PROJECT: WSISD - New Maintenance and Operations Warehouse 24-103.00      DATE: 5/30/2025

SUBJECT: 24-103.00 - New Maintenance and Operations Warehouse - Addendum 01      TRANSMITTAL ID: 00006

ADDENDU NO. 1 TO THE DRAWING  
FOR  
**NEW MAINTENANCE AND OPERATIONS WAREHOUSE**  
**WHITE SETTLEMENT ISD**  
**WHITE SETTLEMENT, TEXAS**

2 BUILDING SECTION  
SCALE: 1/8" = 1'-0"

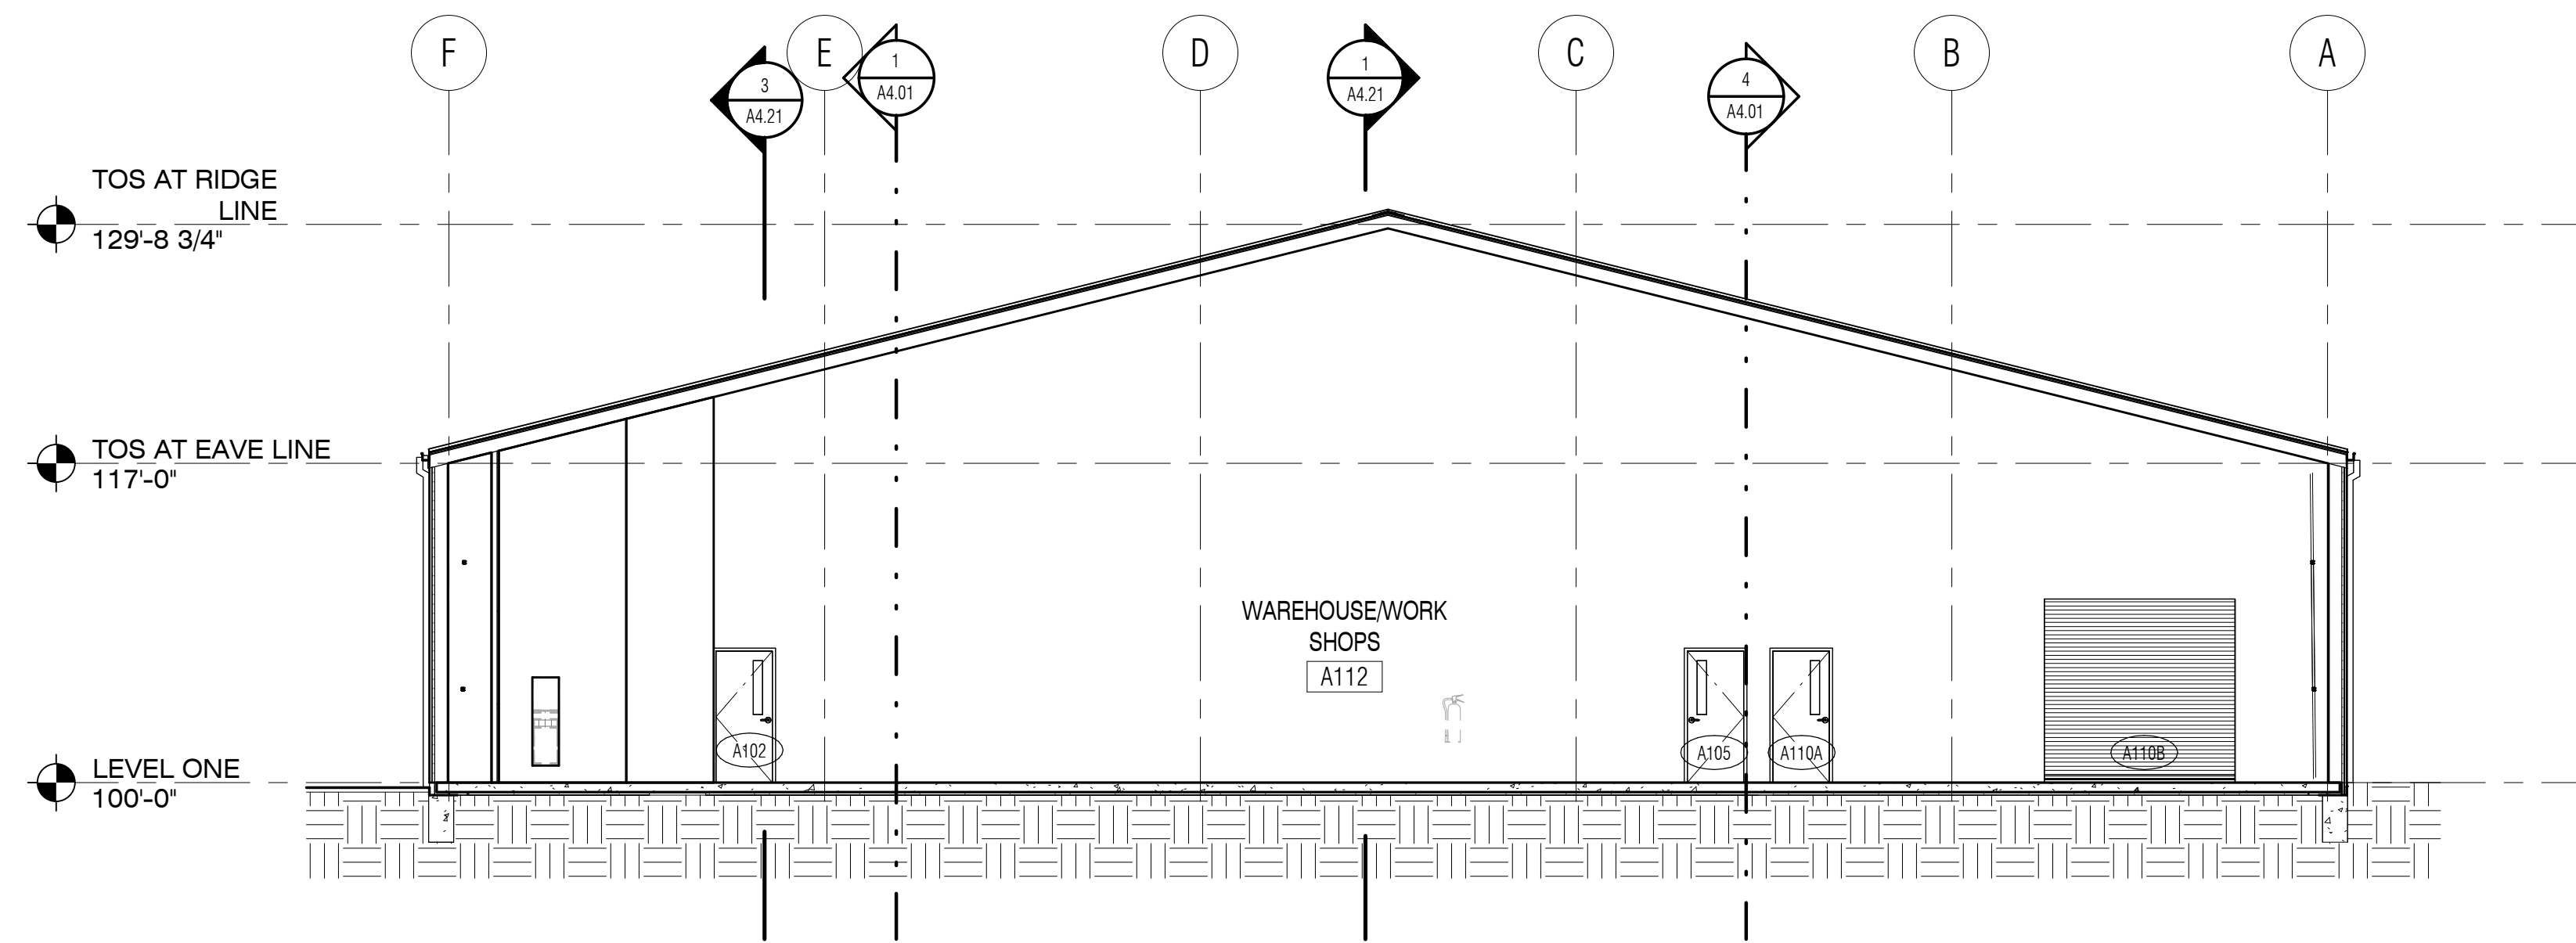
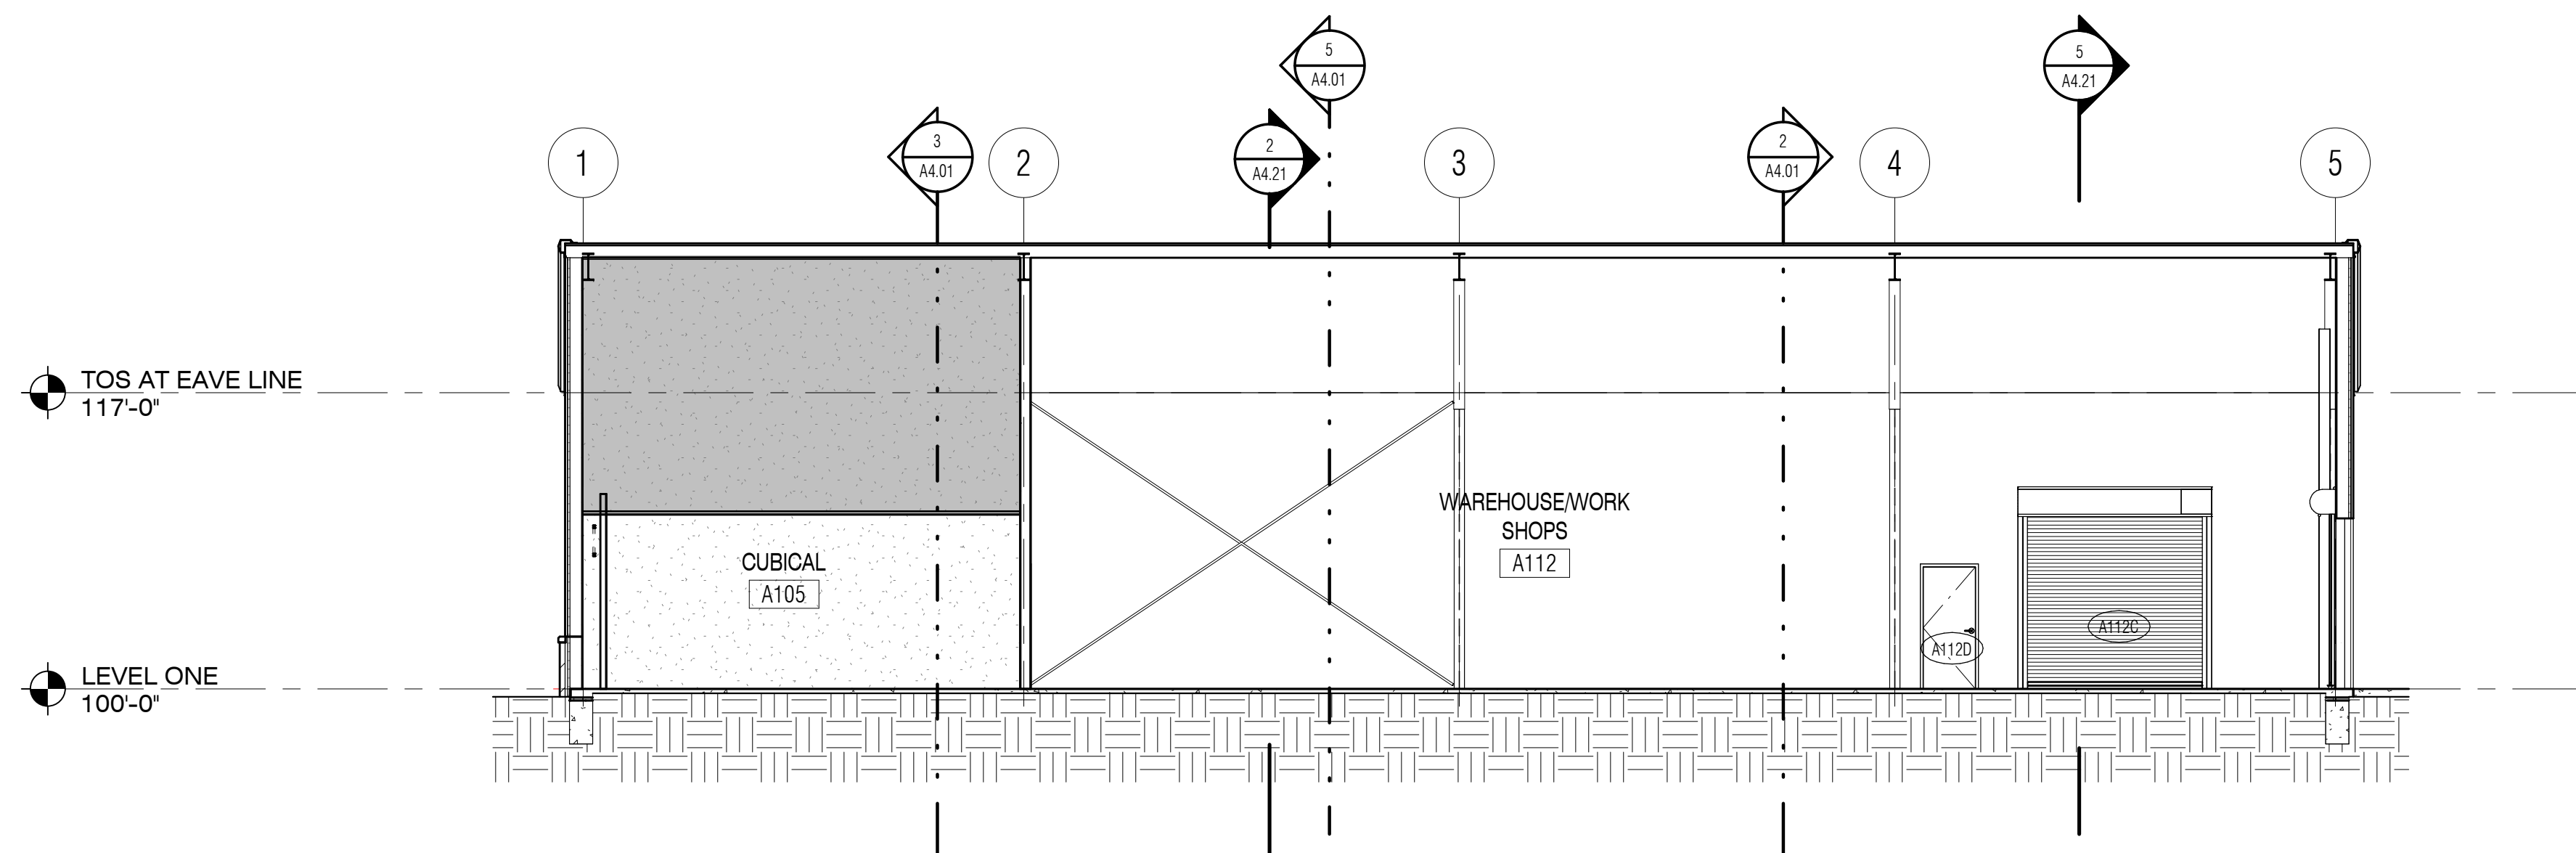
**1.5 SHEET A4.01 BUILDING SECTIONS**

- A. Steel Channel joist bracing added above ceiling to brace wall at back of house.

① **STONE VENEER WALL AT STOREFRONT SILL**  
SCALE: 3" = 1'-0"

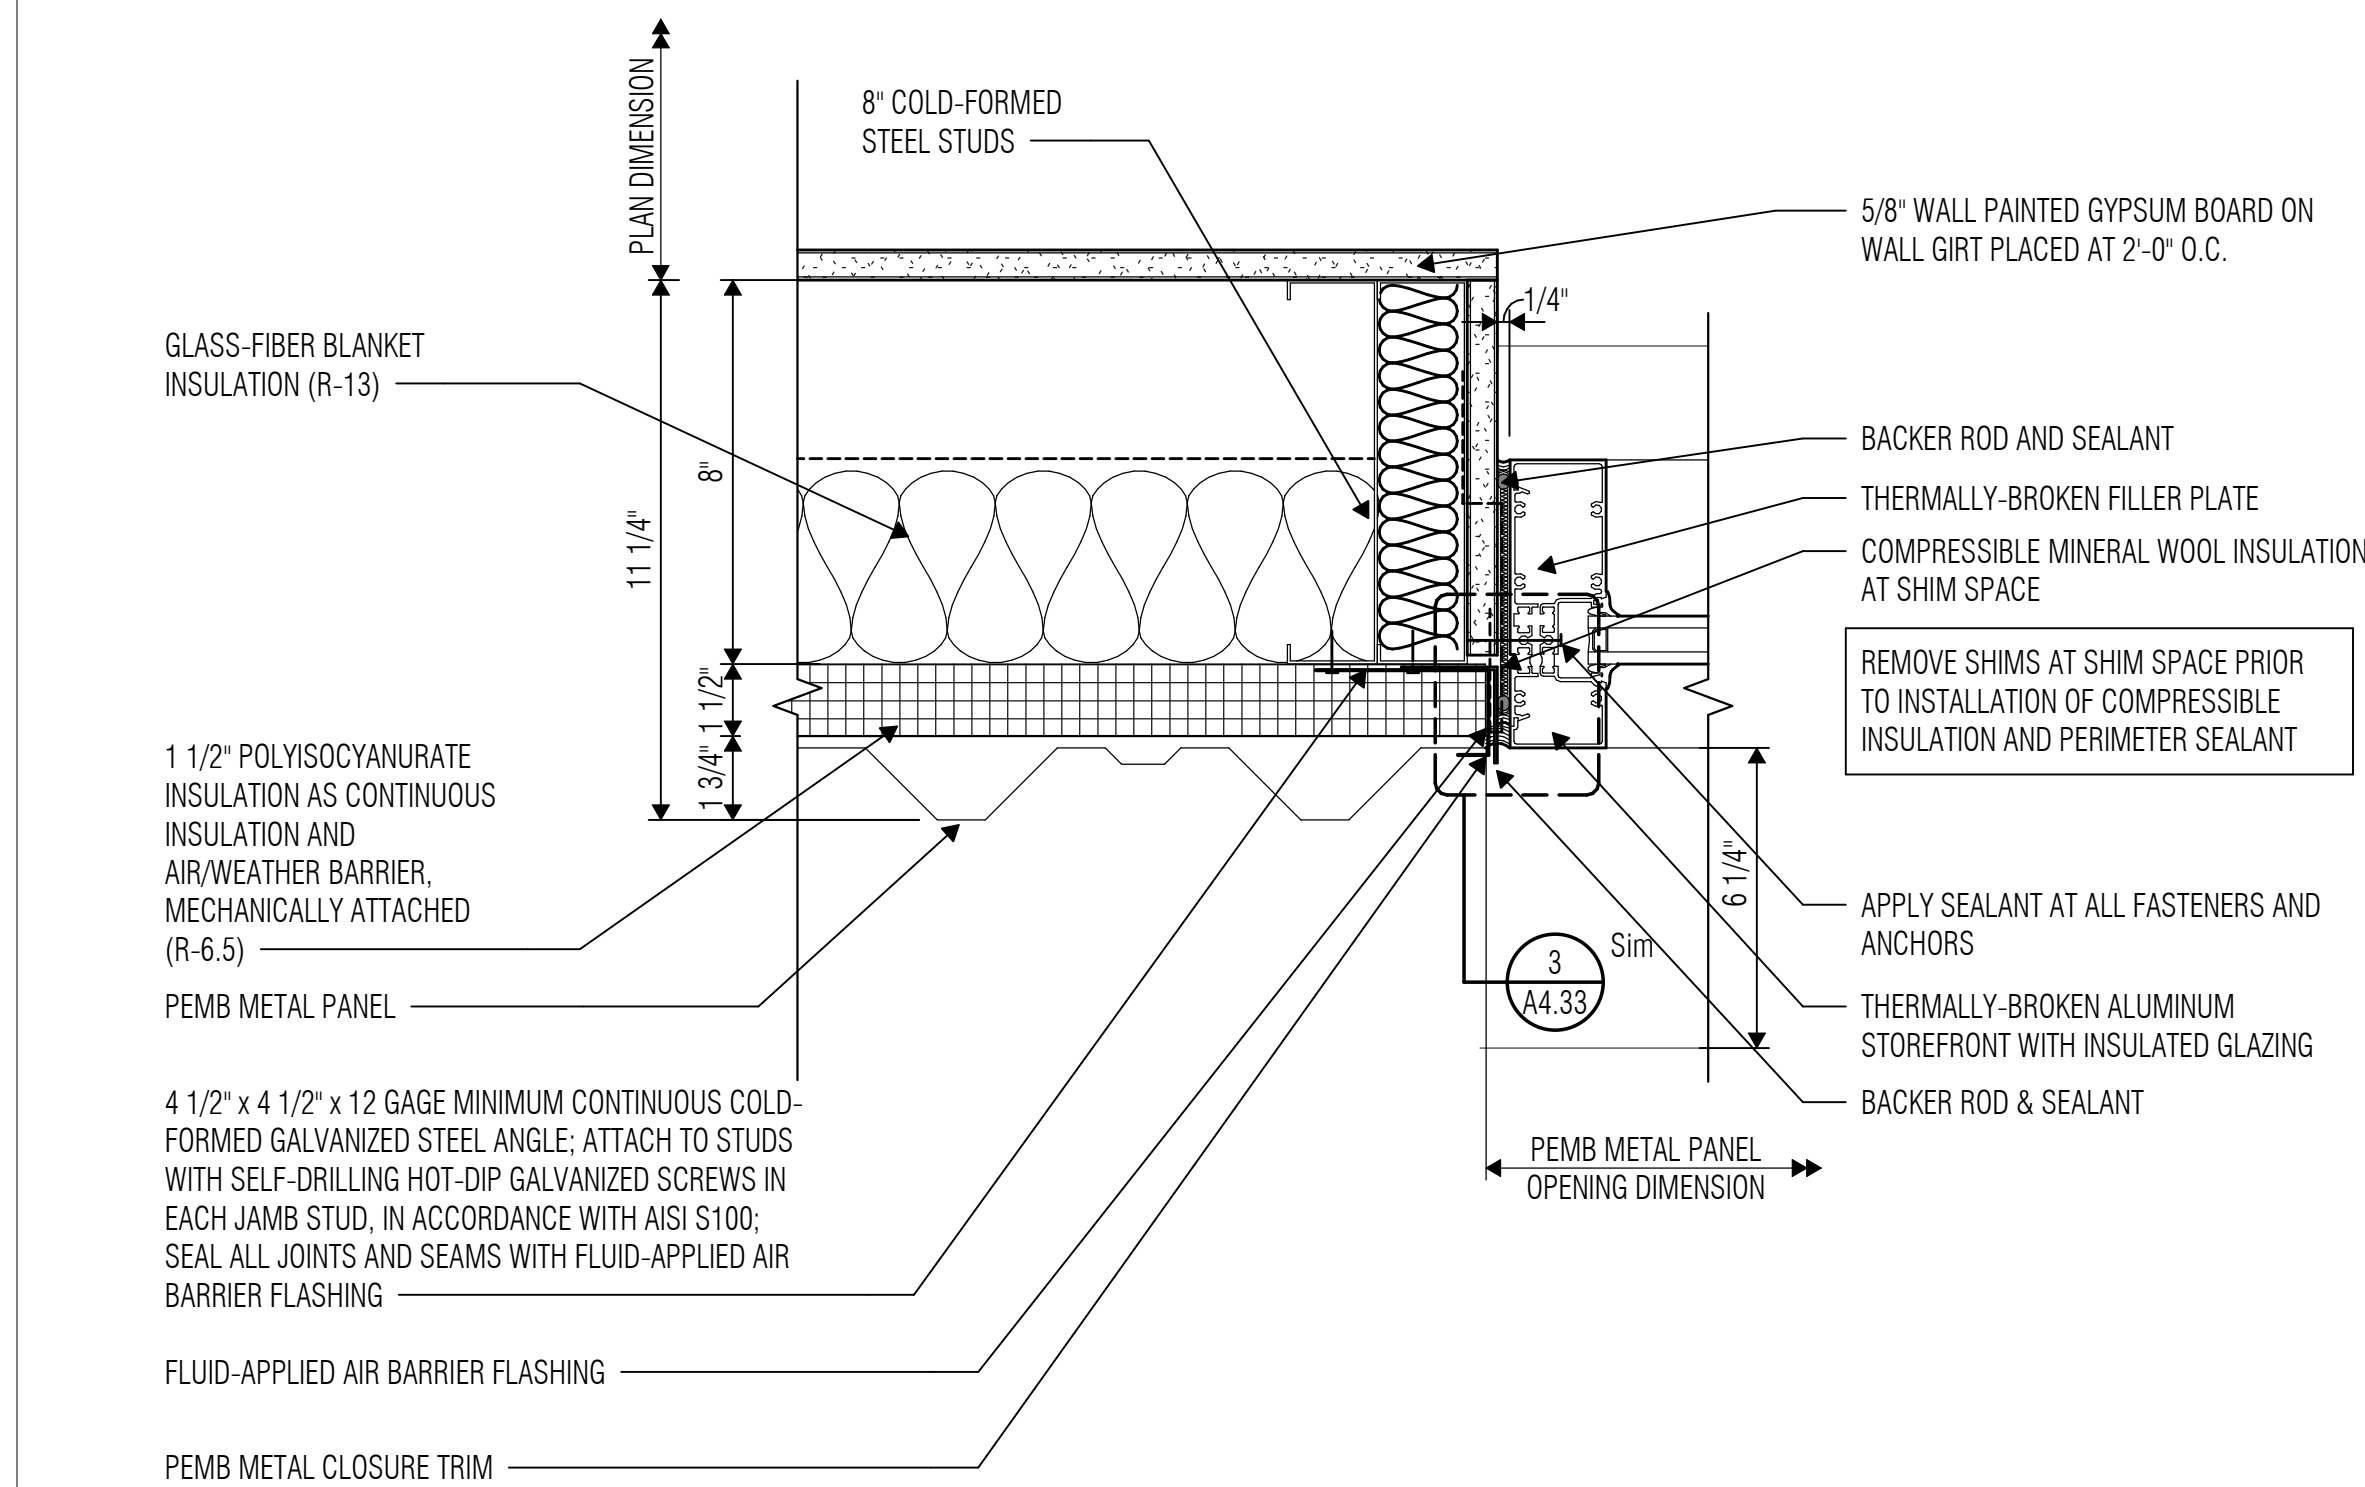
**1.6 SHEET A4.31 BUILDING ASSEMBLY DETAILS**

- A. Detail 1/A4.31 – note stating masonry updated to stone.
